RE: AFD Fire Station 12
11714 Linn Ave. NE
Conceptual Grading and Drainage Plan
Engineer's Stamp Date: no stamp
Hydrology File: L21D036

Based upon the information provided in your submittal received 06/28/2024, the Conceptual Grading Plan **is preliminary approved** for action by the Development Facilitation Team (DFT).

#### SHEET C-101

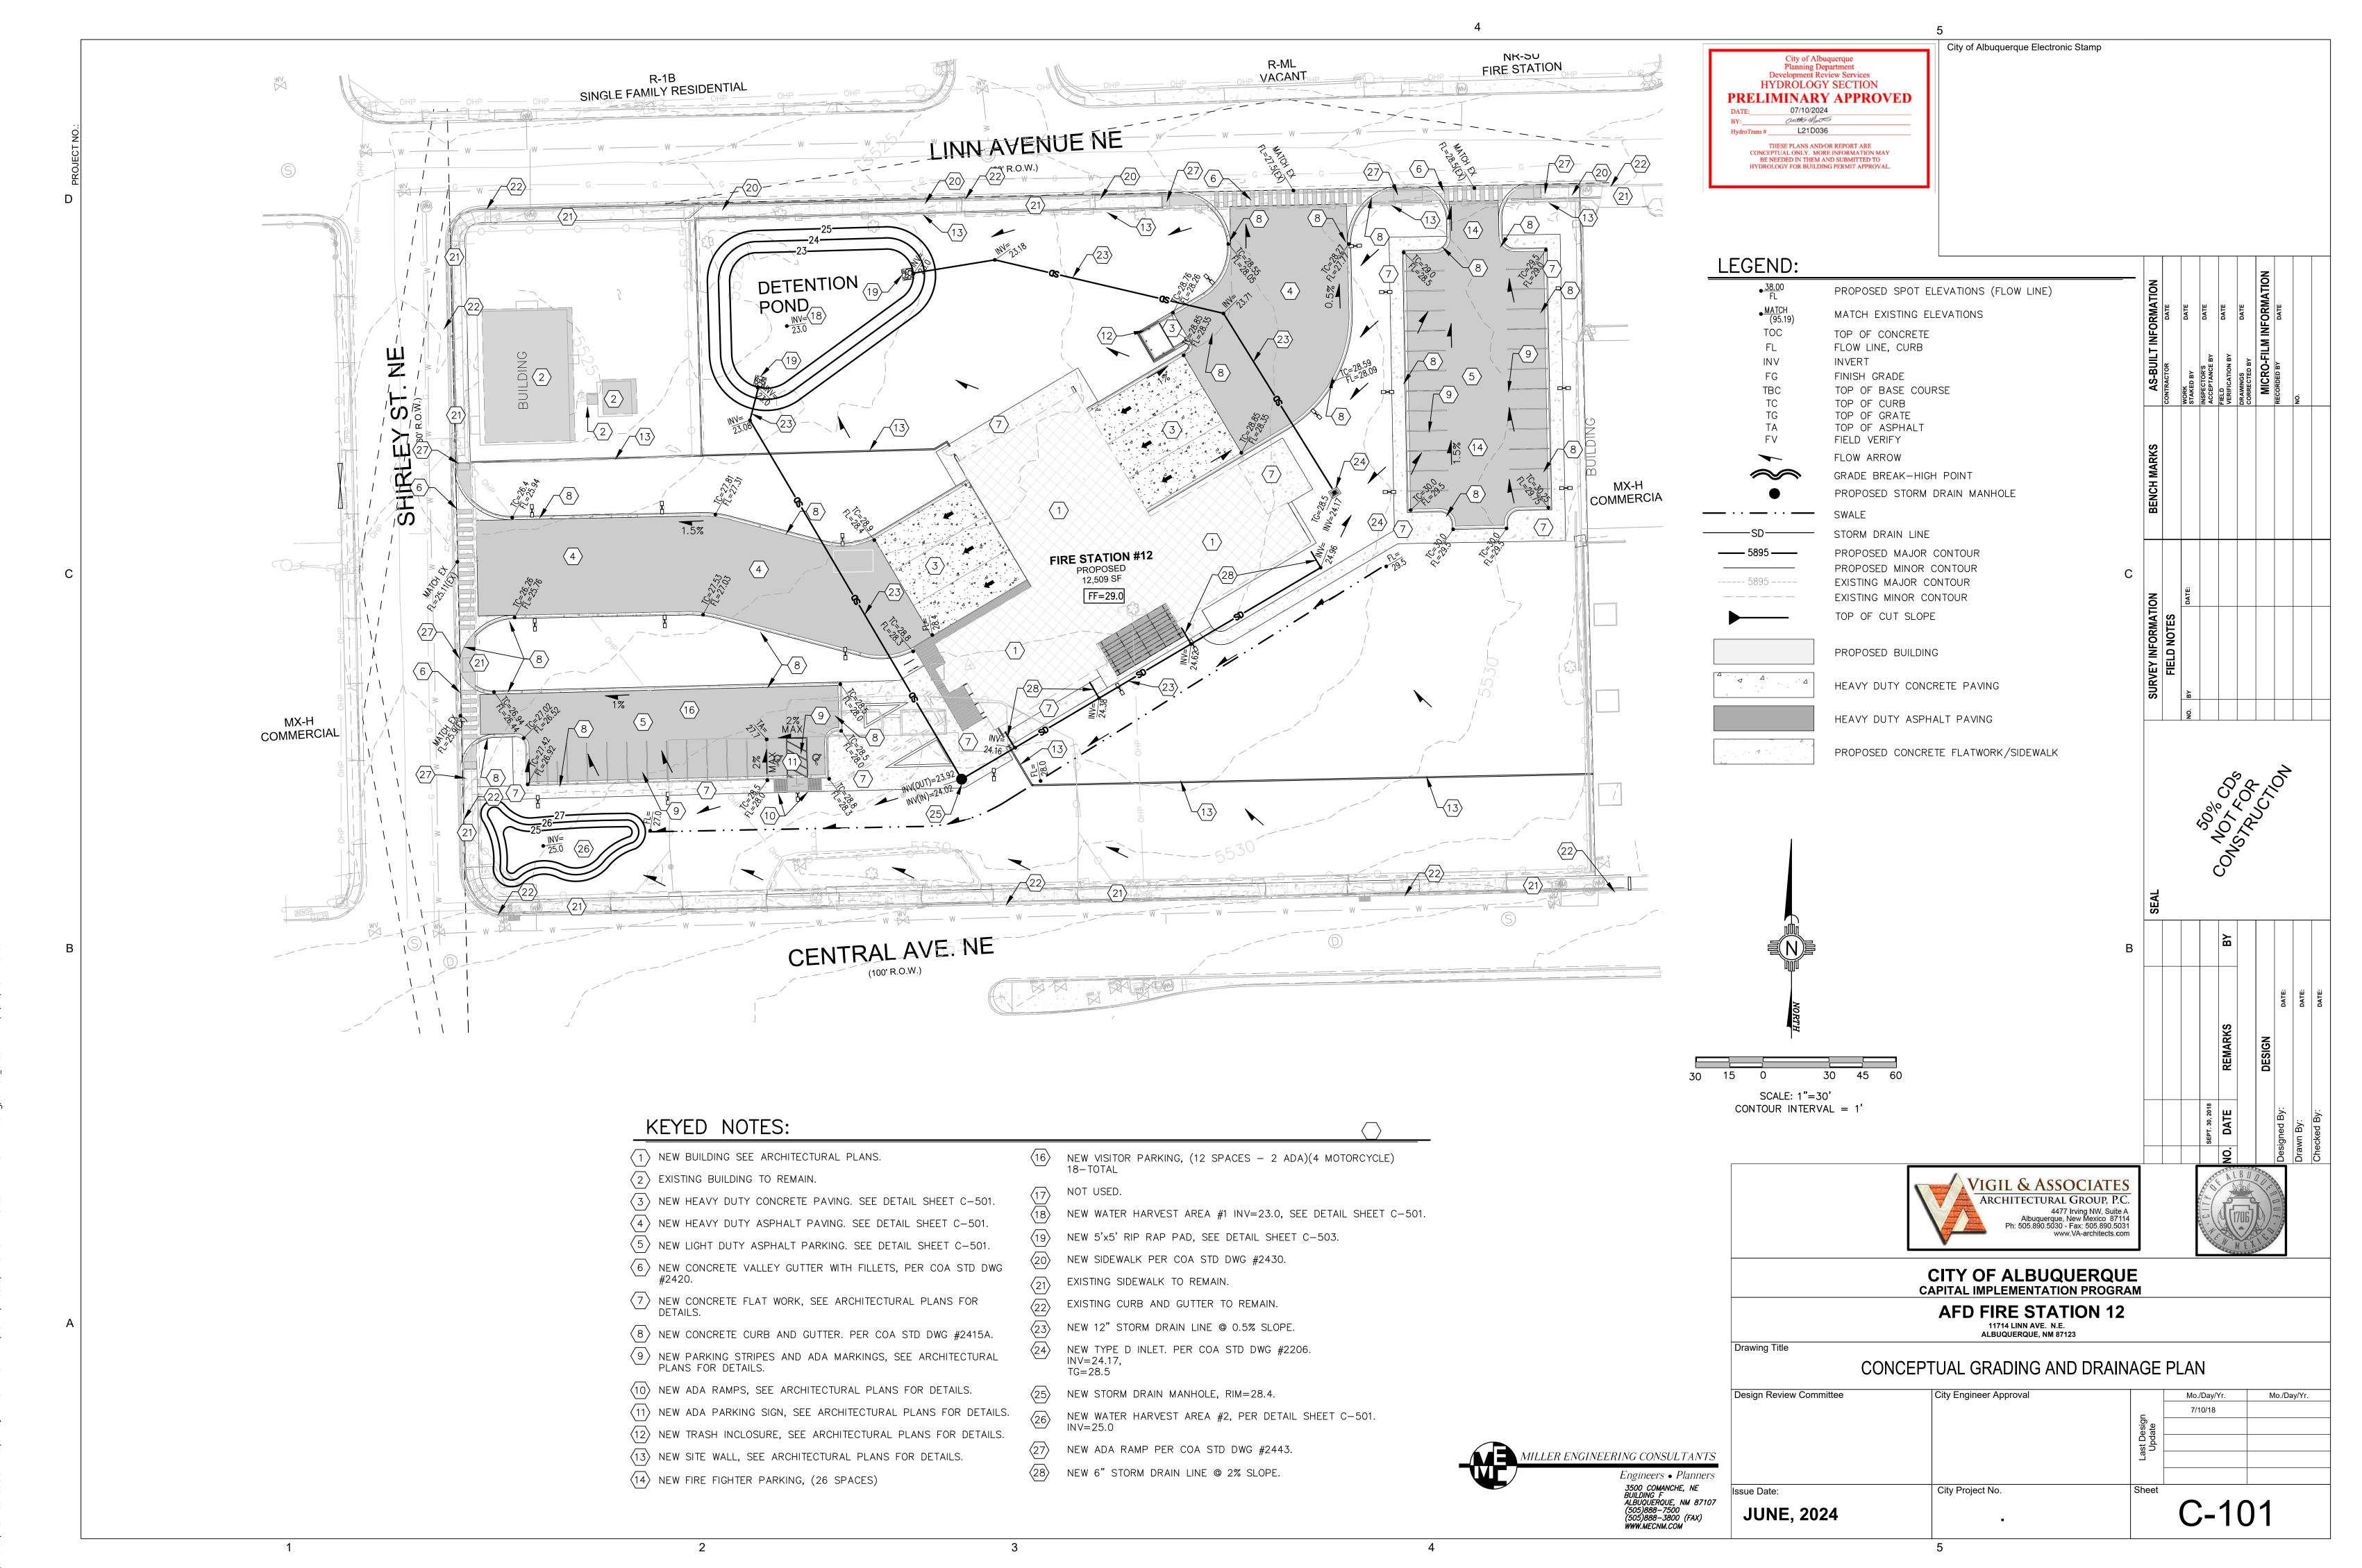
- 3. Please use 1'' = 20' for the scale.
- 4. Please number the ponds and include a label on each with the SWQV and elevation, the 100-year volume and elevation, the peak 100 year inflow and outflow, the spillway crest elevation, the spillway flow depth, and the dam top elevation.
- 5. Please provide the SWQV calculations for each basin draining to each pond. The stormwater quality ponds need to be sized for the areas draining to them.
